**RE: 6/2021/2857/MAJ – TEWIN ROAD, WELWYN GARDEN CITY, AL7 1BD**

Following your objection letter dated 30<sup>th</sup> May 2022, please see responses to the comments you raised.

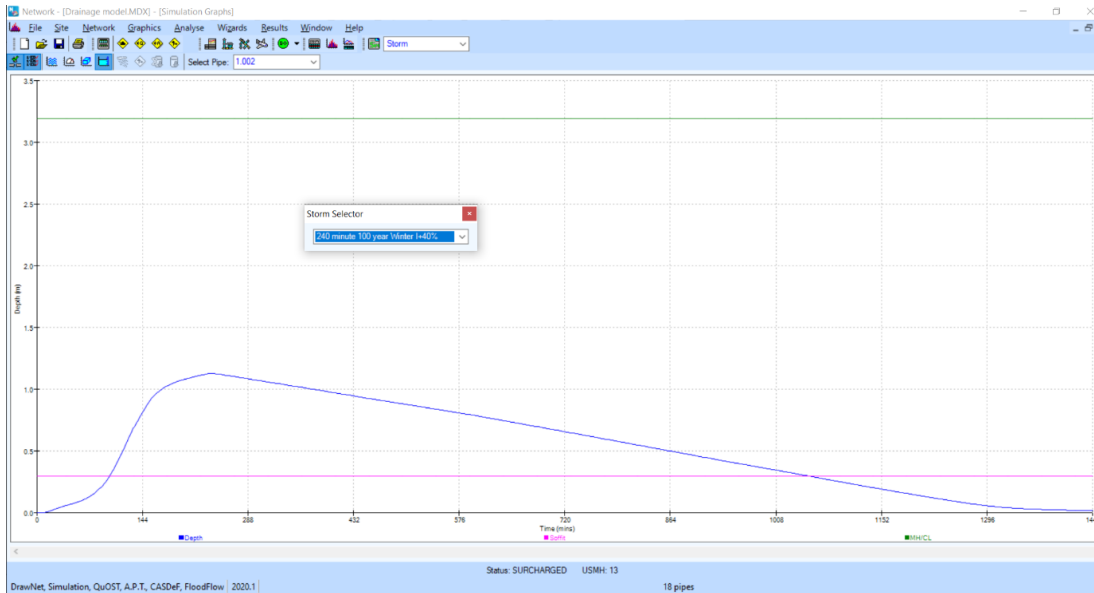
*“2. We are pleased the applicant has provided detailed post-development network calculations for all events up to and including the 1 in 100 year + 40% climate change event. However, we would request the following clarifications. Half drain down times have not been provided. Please could the applicant provide half drain down times for all proposed attenuation features and all storm events, noting that they should not exceed 24 hours.”*

BWB response: Half drain times are only provided for infiltration structures on MicroDrainage. We run the critical storm event over a period of 24 hours and it shows the tanks will be mostly empty within 24 hours as shown below:
